UROSKOP D1 (LX)

Update Instructions

SP022/02/S

Title: Software Update

Fig. 1

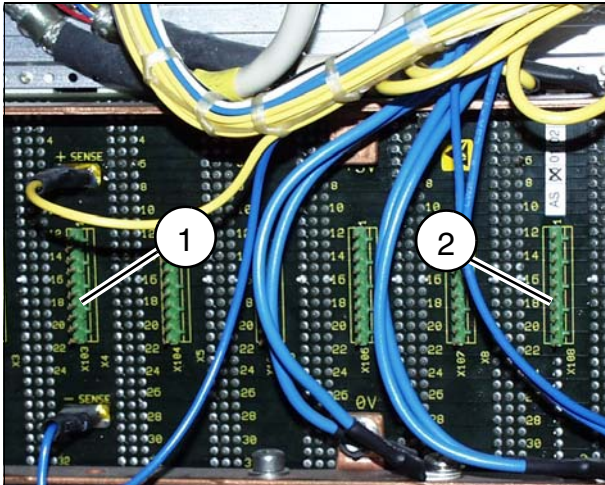
- Swivel out the control unit M20.
- Remove any EMC covers.
- Run the cables on the rear of the electronics frame from terminal strip X103 (1/Fig. 1) to terminal strip X108 (1/Fig. 2)
- Run Cable 1 from X103.7 to X108.7 and Cable 2 from X103.8 to X108.8.
- Reattach the EMC covers, swivel in the control unit and fasten it with screws.
- On PC board D3, solder the following wires (1/Fig. 2):
 - From terminal strip X1/c23 to (1/Fig. 2).
 - From terminal strip X1/c25 to (2/Fig. 2).
- Fit the PC board.
